ALERT SERVICE BULLETIN

429-15-16

Revision B, 15 June 2016

SUBJECT: TAIL ROTOR PITCH LINK BEARING, INSPECTION
AND UPGRADE OF.

Figure 1 – Tail Rotor Pitch Link Bearing Liner

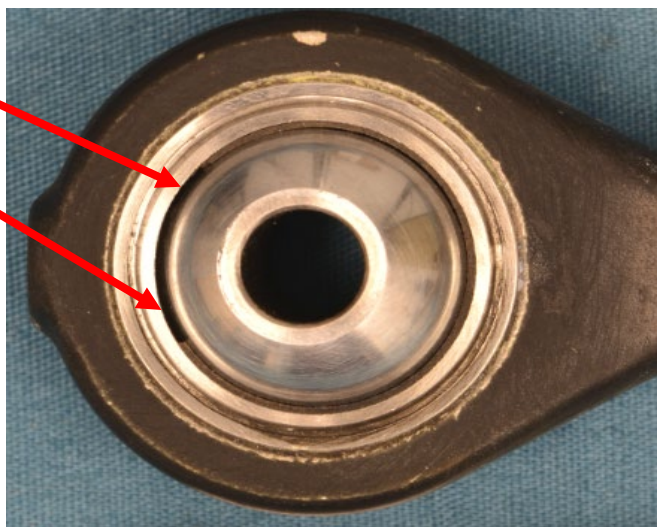
4. Perform a dimensional check of both axial and radial play (BHT-429-MM-1, Chapter 67). With a 10X magnifying glass, visually inspect the bearing liner condition for cracks or deterioration of the liner or if the liner extrudes out of the plane (Figure 1).

- a. Replace any bearing that exceeds the allowable limits and/or if cracks or deterioration of the bearing liner are noted.
 - i. Perform **Part II** of this ASB or replace the affected tail rotor pitch link assembly with an acceptable part.

Figure 2 – Example of Sealant (C-251) Installation

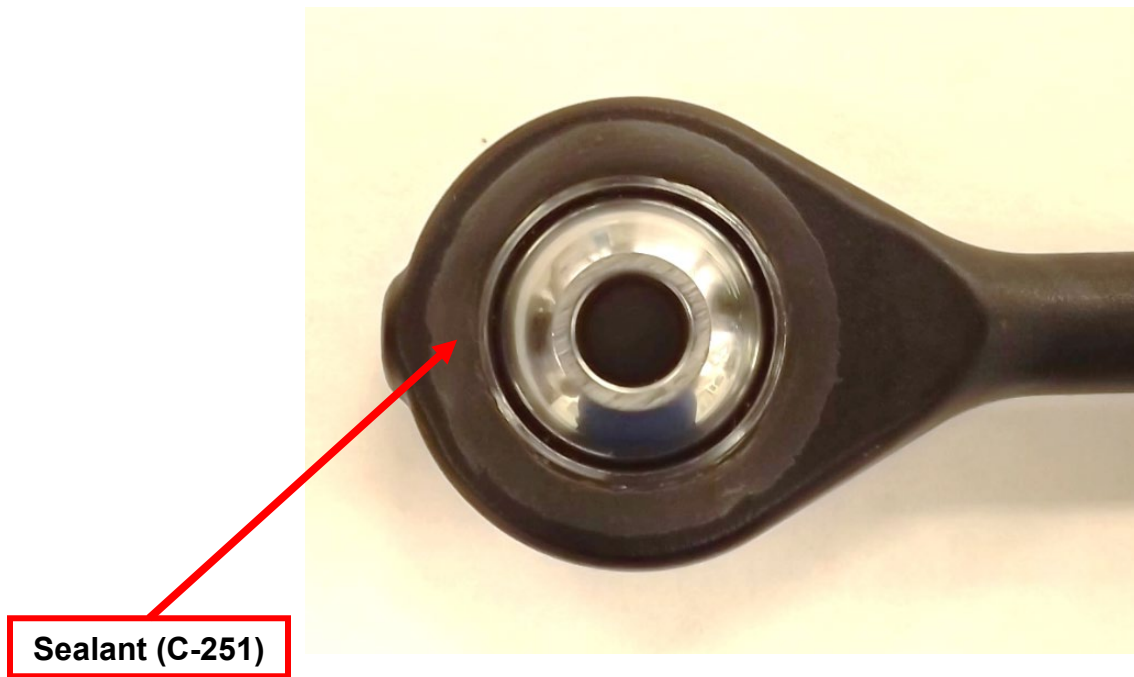
3. Install the new bearing 429-312-107-103 (BHT-429-MM-1, Chapter 67).
4. Clean the affected area with isopropyl alcohol (C-285). Apply corrosion preventative sealant (C-251) to the bearing roll stake lip and the pitch link (Figure 2).
 - a. Make sure there are no pin holes or voids present in the sealant.
 - b. The thickness of the sealant should not exceed 0.025 inch (0.64 mm), should extend over the roll staked lip by a minimum of 0.030 inch (0.76 mm), and remain clear of the bearing ball.
5. Reidentify the tail rotor pitch link assembly with a white permanent fine point marker, or equivalent, as follows:
